SUNDRY NOTICES AND REPORTS ON WELLS

Lost Tank 4 #16

30-015-37957

**Conditions of Approval**

Figure 1 – Ultrasonic Imaging Log 5750 ft – 5950 ft

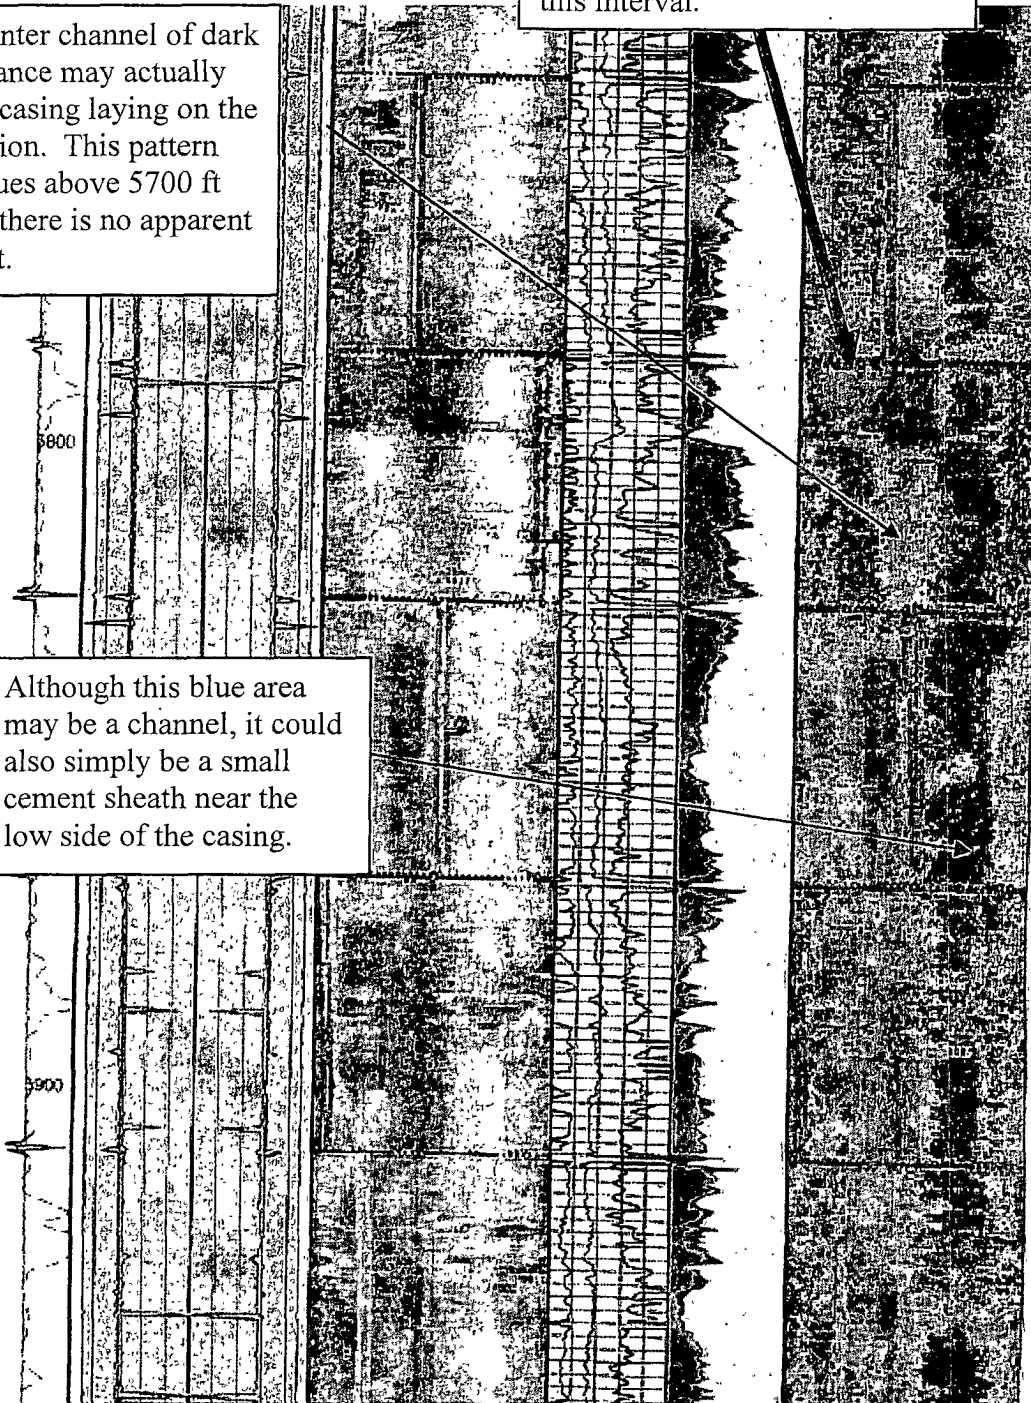
- From 6800 ft to 5700 ft, the bonding is marginal to poor, but I believe that the interval is adequately cemented. The main evidences for this are 1) The sonic tool, the CBL, does not show heavy collar rings, and shows good formation signals, and 2) the ultrasonic tool, the USI, shows scattered amounts of cement. I do think that the centralization in this interval is poor. It appears that the casing is lying on bottom and that there is a small cement sheath next to the pipe. See Figure 1.

Scattered sections of higher impedance values indicate that there may be some cement in this interval.

The center channel of dark impedance may actually be the casing laying on the formation. This pattern continues above 5700 ft where there is no apparent cement.

Although this blue area may be a channel, it could also simply be a small cement sheath near the low side of the casing.

Figure 2 – Ultrasonic Log – 5500 ft – 5700 ft

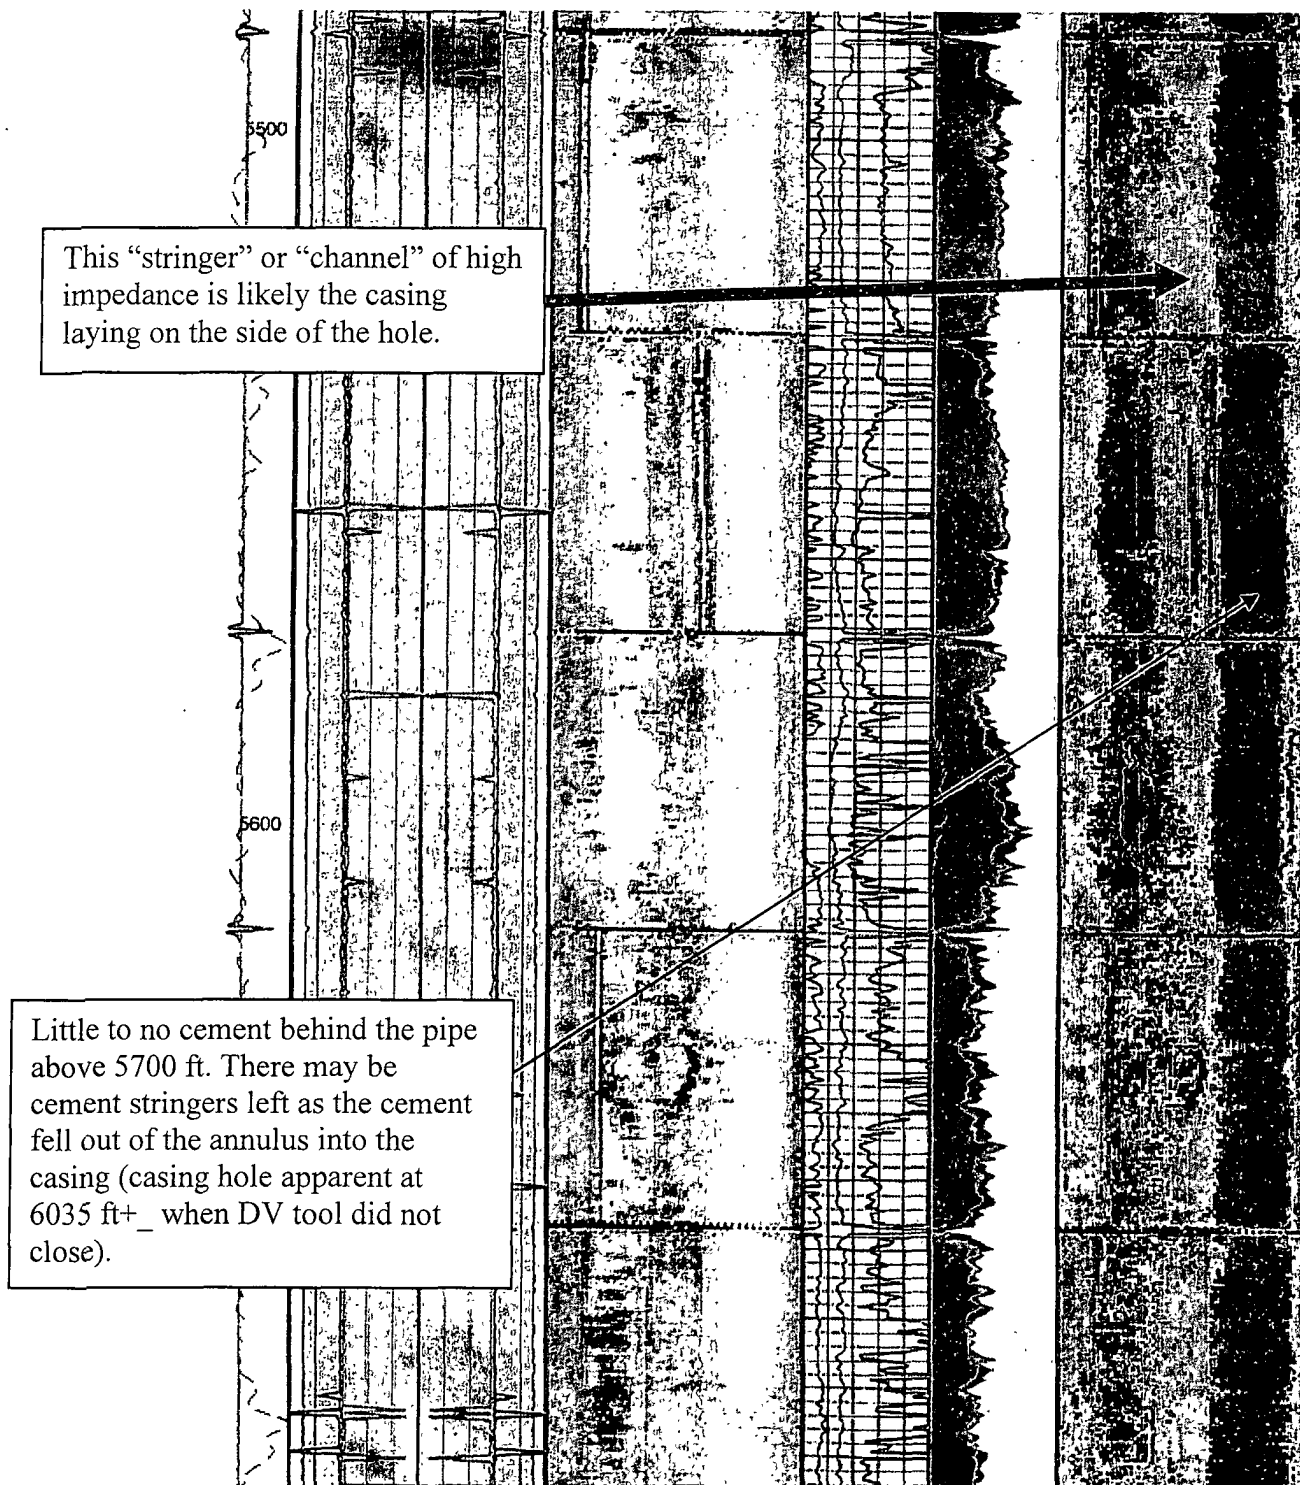
- From 5700 ft to 4600 ft, there is likely no cement, or very poor cement. The dark channel at the bottom of the USIT in this section is likely the casing lying against the formation. The CBL shows loud echoing collar rings and very high, consistent amplitudes. Note that the CBL also shows strong formation signals (which could be coming from the casing lying against the formation). See Figure 2.

Figure 3 – Ultrasonic Imaging Log @ +/- 3900 ft

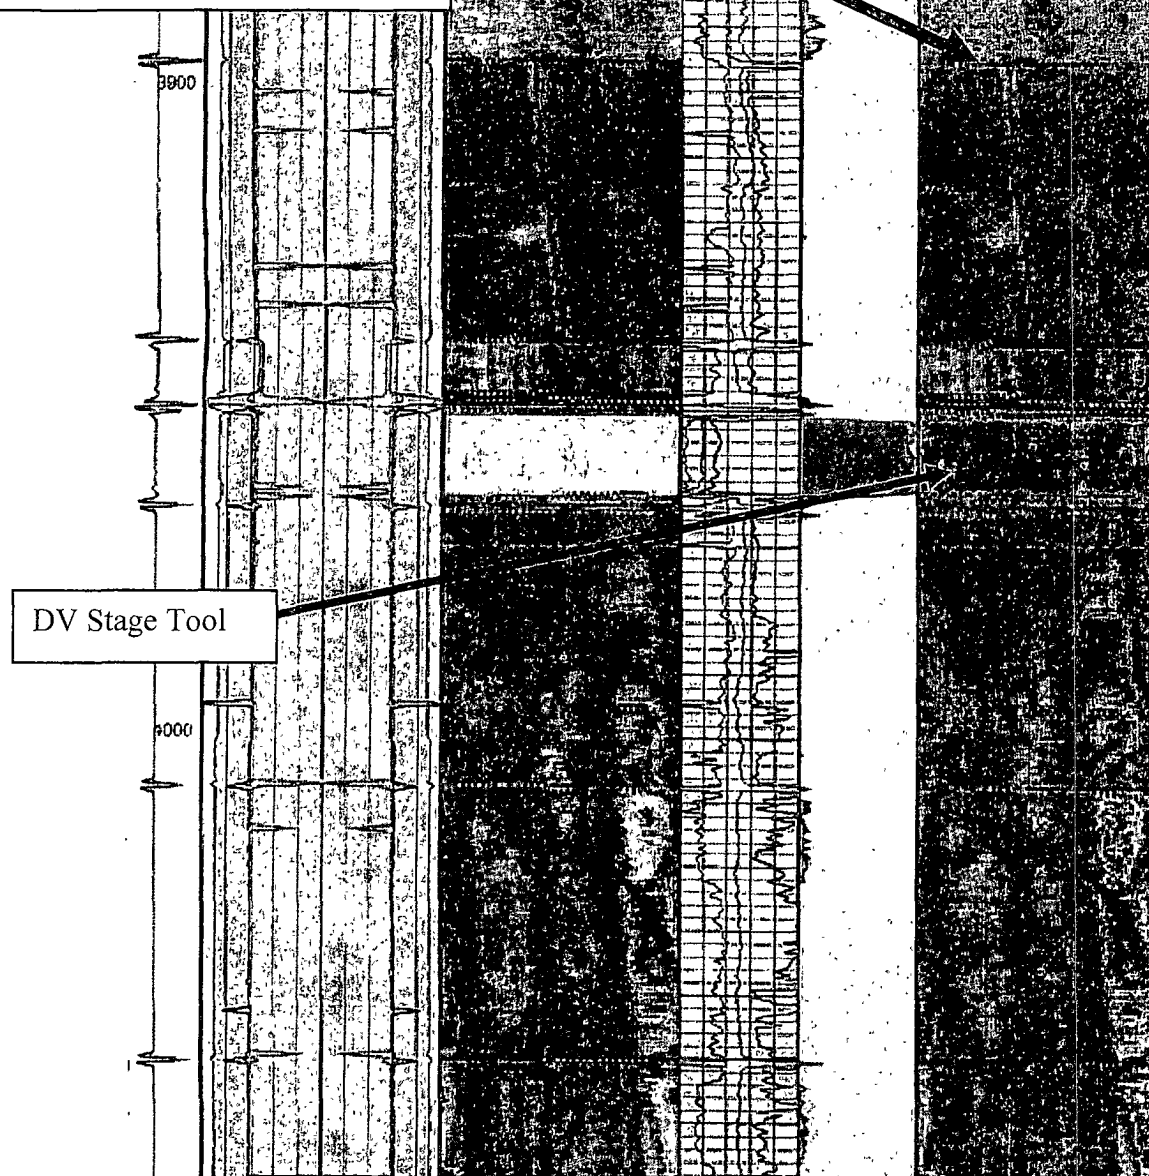
- From 4600 to 3890, there is excellent cement bonding and adequate isolation. The DV tool can be noticed at +/- 3950. See Figure 3.
- From 3890 to 1260 ft, there is adequate cement. See Figure 4.

Large change in impedance value and bonding at a casing collar. This usually means that the casing below (in this case) is different, old, rusty, and is bonding with the cement better than the above joints. This also means that there is probably good cement above this joint too. The bond log confirms this.

Figure 5 – Bond Log 1100 ft – 1300 ft. Top-Of-Cement

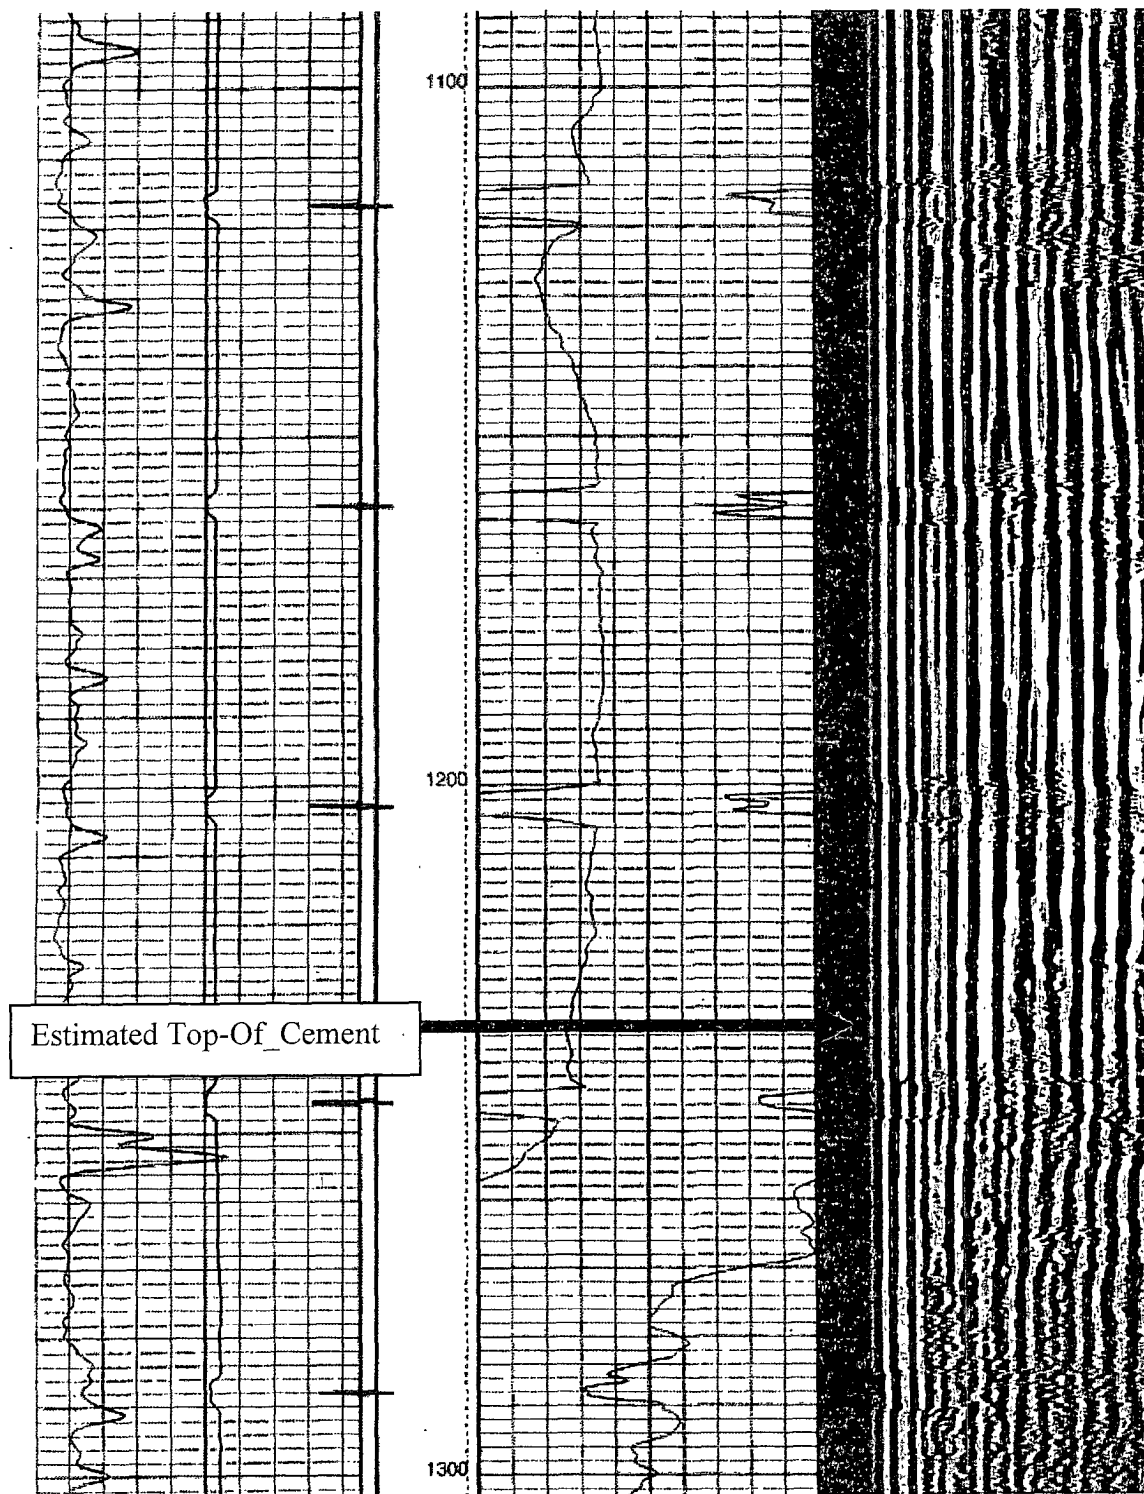
- The TOC is location at +/- 1260 ft. There is no cement evident in the interval above 1260 ft. See Figure 5.
